Product Change Notification

Date Issued :	January 26, 2023	PCN Number :	513283
Reason for Change :	Capacity change or tool replacement		
Description of Change :	This notification is to inform you that Molex Lincoln Nebraska is going to add additional tooling to meet the current and future demands of the product referenced below. There will be no changes in fit, form or function from additional tooling when compared to the existing tooling.		
Assessment of Change :	First Article Inspection SPC / Capability Studies		
Planned Implementation Date :	July 27, 2023		
Sample Availability Date:	May 24, 2023		
Internal Molex Qualification Date :	May 24, 2023		
Last date to request Samples by Customer :	June 30, 2023		
Traceability Code Markings / Date :	Product made after planned implementation date can contain the change

■ 42240

— MiniFit Vertical BMI Header

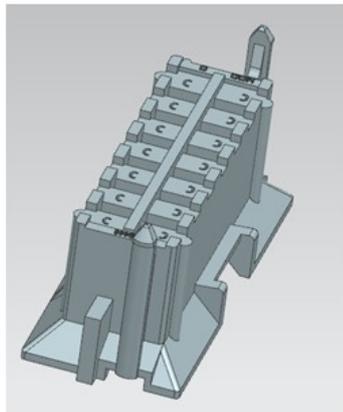
- To ensure exceptional quality, Molex Lincoln, Nebraska is going to replace tooling which produces the affected part numbers
 - New tooling will be an exact replica of current tooling
- There is NO impact to Fit, Form or Function
- Samples available upon request after date shown above
- Part Numbers Impacted
 - See attached list
